Rolling Meadows Substation
Construction of a New Electrical Substation
including Grading, Drainage, and Surface Improvements
El Paso County, Colorado

EPC STORMWATER REVIEW COMMENTS
IN ORANGE BOXES WITH BLACK TEXT

Dwn: TMC		Date: 06/22/26	
Appd: DWS		Date: 06/22/26	
DWS			
S1183-A-01-001			
Tri-State Generation and Transmission Association, Inc. 1100 W. 116th Ave. P.O. Box 33895 Denver, Colorado 80233 303-452-6111		Rolling Meadows Substation Facility Civil Sheets S1183-A-01-SHEETS.dwg	
ROLLING MEADOWS SUBSTATION 115/12.47KV COVER SHEET		TRI-STATE GENERATION & TRANSMISSION ASSOCIATION, INCORPORATED	
UPDATED BY: WLUOGATE		6/19/2026 9:37 AM	
Contract: 4713		No.	
		Date	
		Dwn.	
		Appd.	
		Revision	
		M.F.	
		Dwg. No.	
		Mfr.	
		Reference Drawings	
		Drawing Title

CONCRETE OUTLET STRUCTURE
SIDE VIEW
N.T.S.

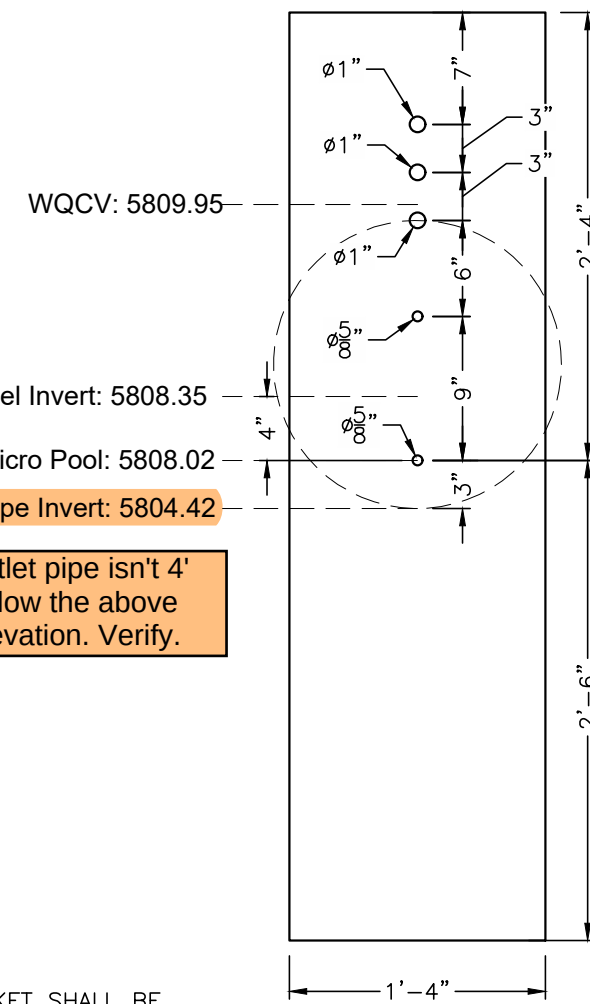
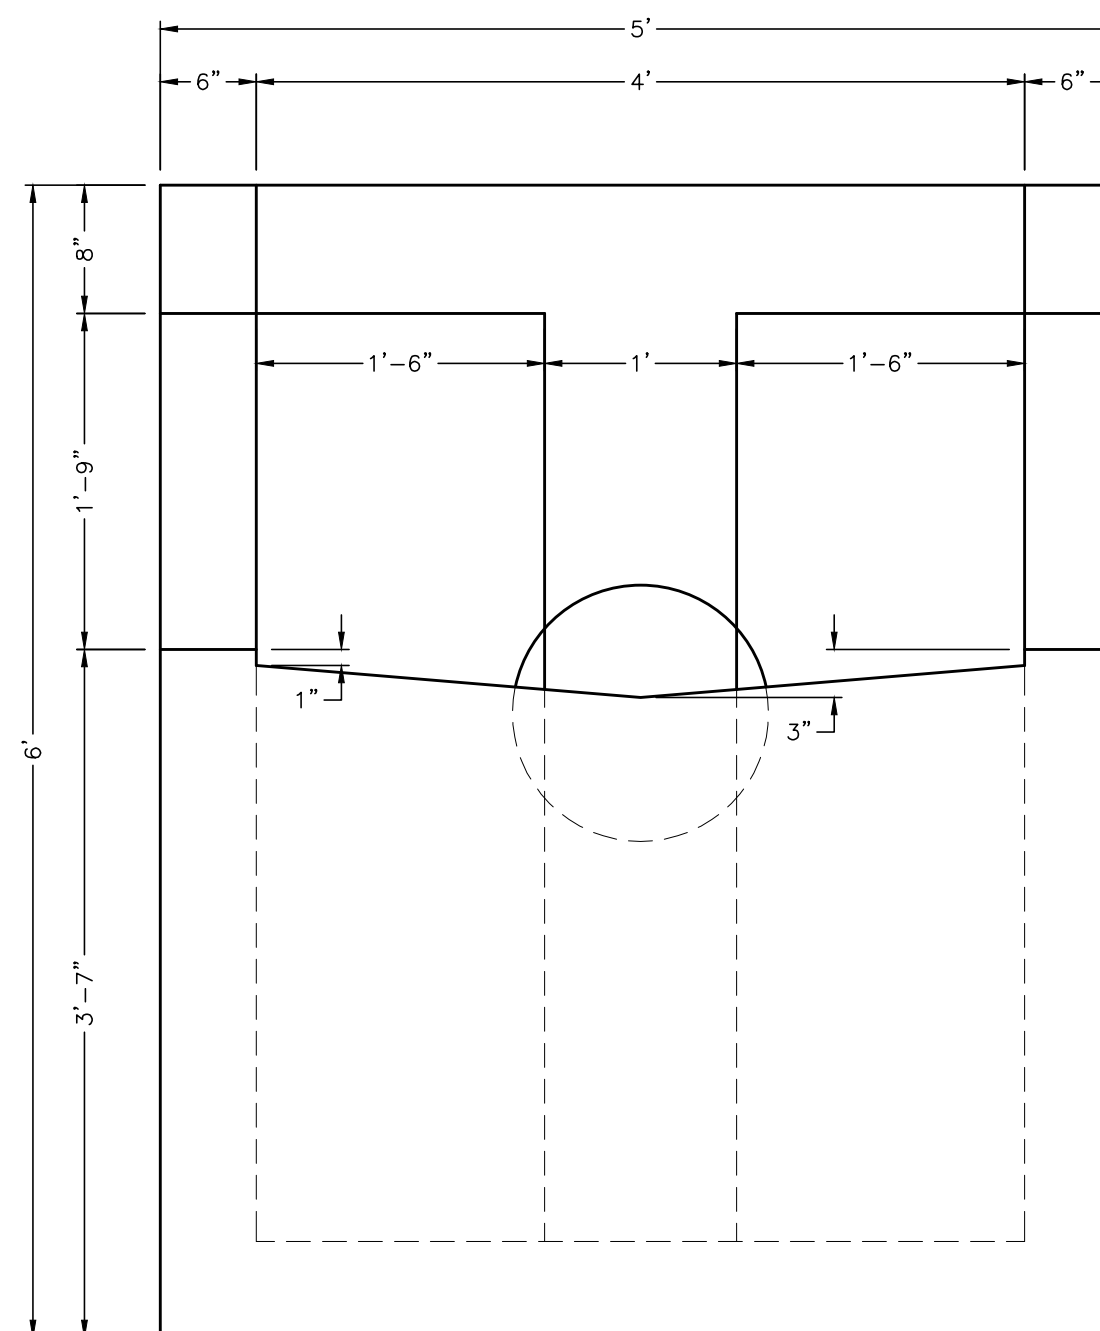
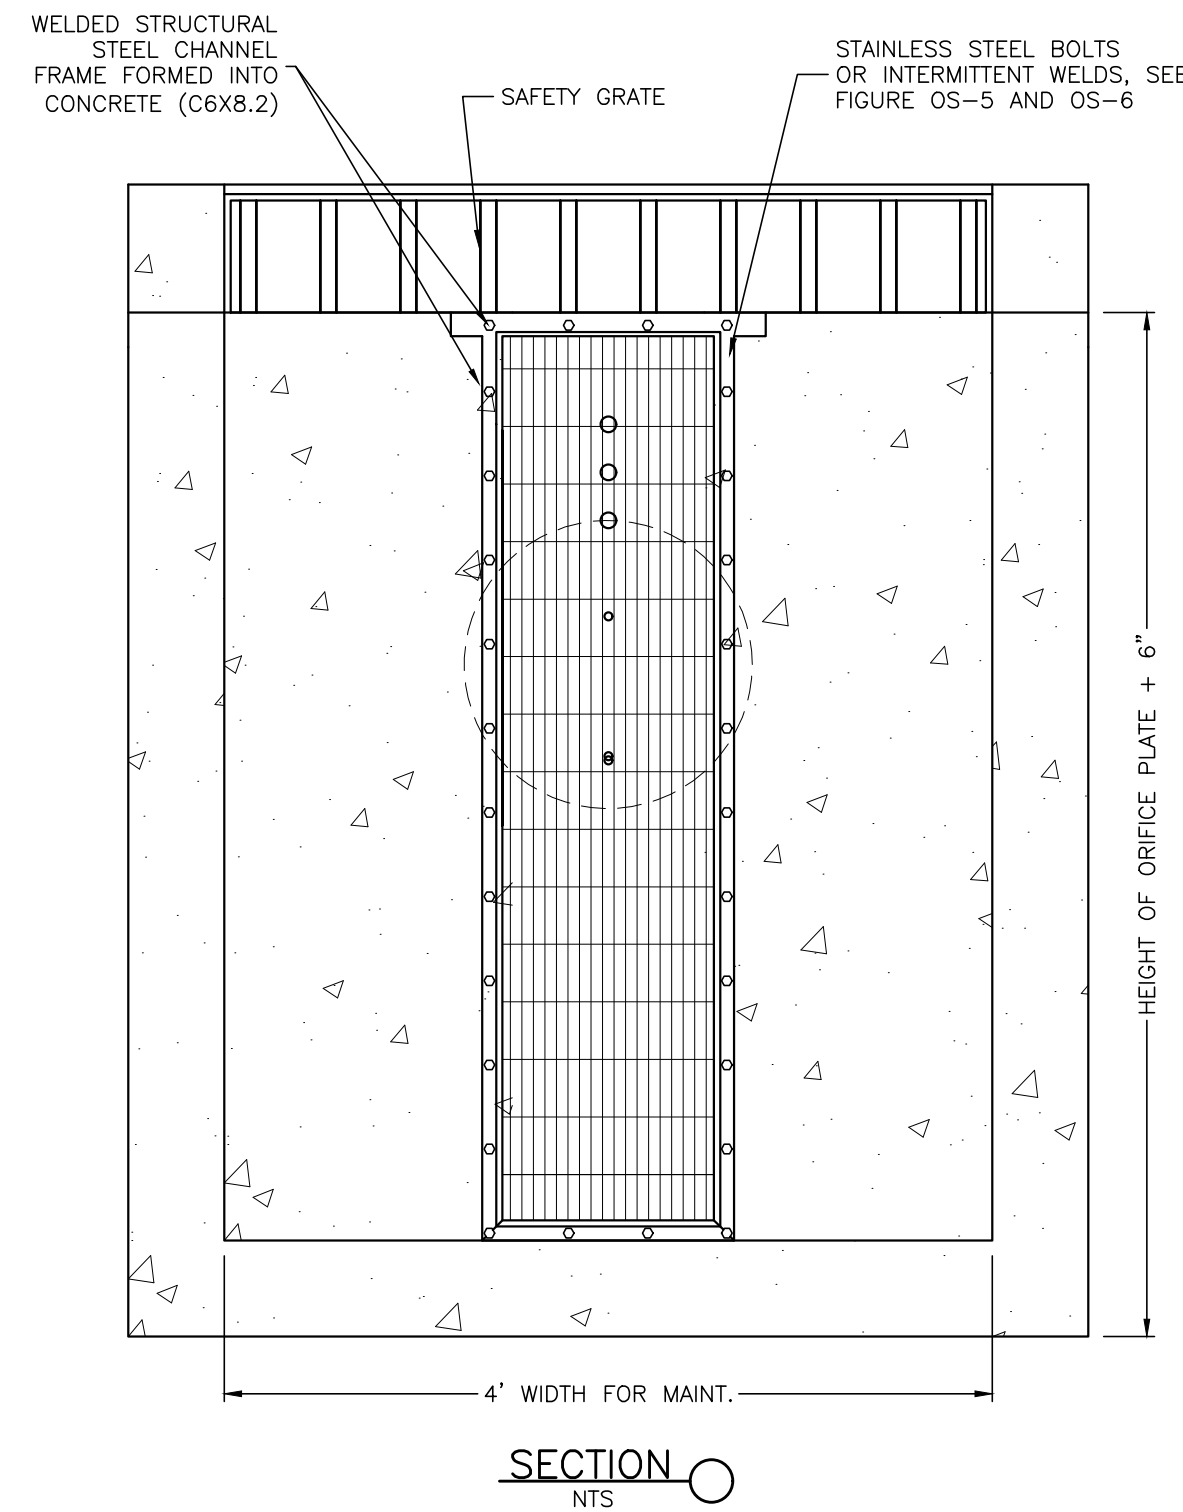
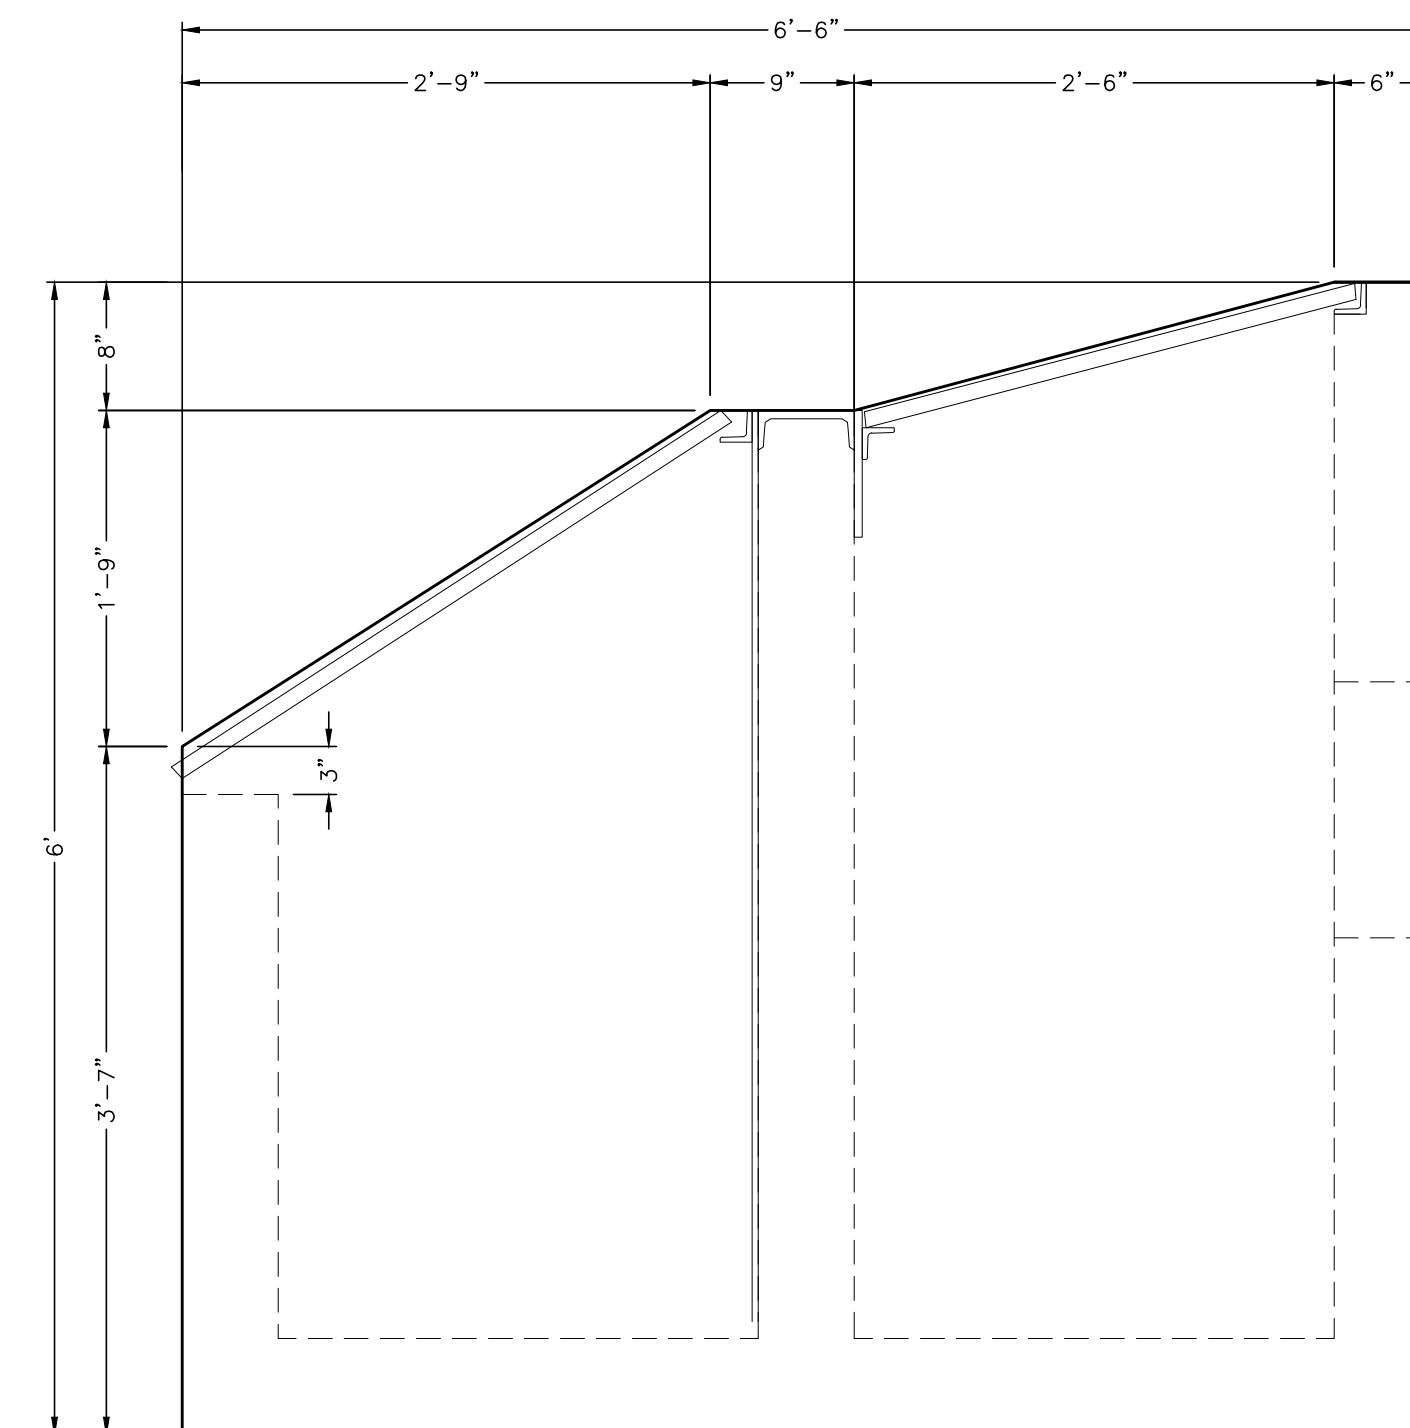
Provide restrictor plate detail.

Provide detail for restrictor plat, as shown on MHFD spreadsheet
